283 and 285 McLeod Street, Ottawa

Urban Design Brief
Site Plan Control
January 25, 2024

Responses to Pre-Consultation Comments

Figure 2: Proposed Site Plan

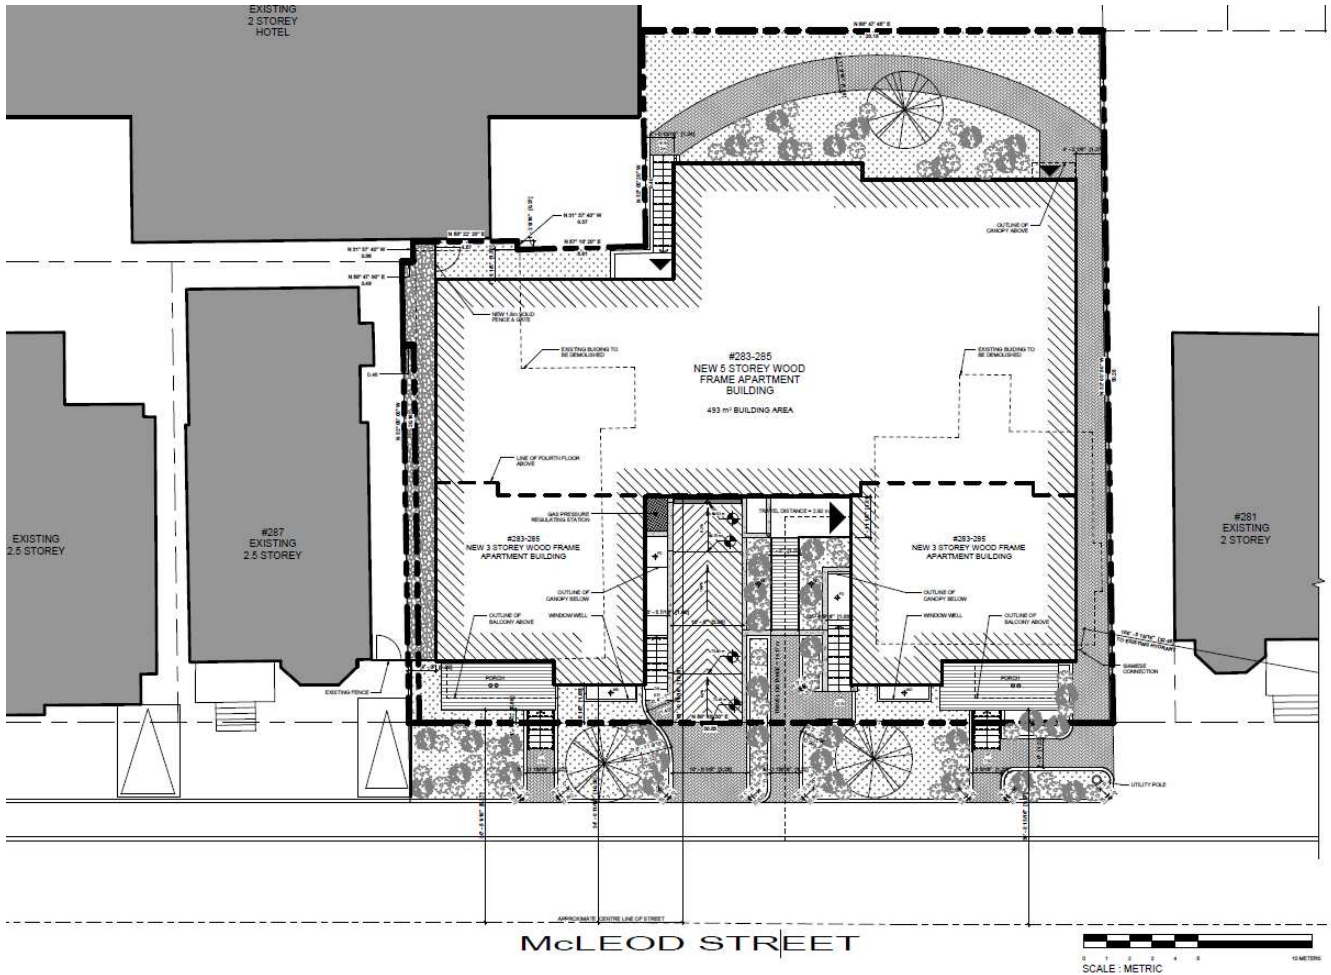
1. With regards to the sunken areas, we note that they are generally discouraged if they can be avoided.
 - a. Negative impacts to the front yard and streetscape posed by the sunken area can be avoided with appropriate landscaping treatment.
 - b. The sunken amenity area at the rear appears as though it could be avoided.

2. There are potential conflicts between automobiles and pedestrian where the sunken driveway is paired with the unit access to its left (west).

3. Ensure accessibility standards are met when considering access pathways through the site. The rightmost pathway seems to be leading to an at-grade amenity area at the rear, so accessible access should be expected.

4. Look for opportunities to consolidate walkways where/if possible.

5. Encroachment agreement will be needed for proposed features projecting within the ROW at the front of the property.

6. Site Plan should show all applicable dimensions and setbacks. Please include a zoning matrix in future submissions which outlines how the proposed development is in conformity with the applicable zoning standards.

8. Sunken Courtyard/amenity space: We continue to have concerns about the sunken courtyard, its livability and access to natural light. We recommend removal of the rear yard amenity if it does not represent part of the required area and use the space instead for landscaping and trees. Alternatively, if the amenity is to remain at that level for accessibility reasons, consider stepping the bounding walls to create a more welcoming terraced condition.

9. Unit access adjacent to parking ramp: We continue to have concerns about the potential conflict between cars accessing the underground parking and the pedestrians accessing the conjoined western basement unit. We recommend relocating the access to a more protected location, perhaps further to the west, or providing sufficient separation between cars and pedestrians at this location.

10. Main entrance clearly visible from the street/canopy: The main entrance for the majority of the building occupants is not directly visible from the street. We recommend providing additional features (ie. Canopy and exterior lighting) to ensure visibility and visitor access consideration.

Response: The two sunken entries located in the entrance courtyard should not have a negative impact on the McLeod Street streetscape with the implementation of appropriate landscape elements. In reality, these entrances are minimally 'sunken' as they follow the slope of the ramp allowing for an abundance of natural light into the lower level units, making them more livable. More importantly, these two entry conditions help to animate the entrance courtyard.

The rear yard sunken amenity space has been eliminated.

Response: With an appropriate curb height for the ramp, there should not be any safety issues/conflict with the two apartment entry conditions, especially given that the ramp is heated, there are only eight underground parking spaces and the ramp is 3.6 metres wide encouraging reduced vehicle speeds.

Response: The easterly pathway to the rear yard varies in width from 1.21m to 1.54m, however, in accordance with OADS 3.3.1 (Rest Areas), there are two 1.8m x 1.8m rest areas which are located 21 metres apart.

Response: Pathways have been consolidated and are consistent with the 'rhythm' of entrance pathways along McLeod Street.

Response: Acknowledged. This will be obtained prior to building permit application.

Response: The updated Site Plan shows all required information.

Response: The rear yard sunken amenity space has been eliminated.

Response: With an appropriate curb height for the ramp, there should not be any safety issues/conflict with the two apartment entry conditions, especially given that the ramp is heated, there are only eight underground parking spaces and the ramp is 3.6 metres wide encouraging reduced vehicle speeds.

Response: The following elements have been incorporated to 'announce' the apartment entry:

- **A Canopy**
- **A Sculpture, with a possible wall fountain**
- **Night lighting**
- **Alignment of the entrance pathway, including its bridge**
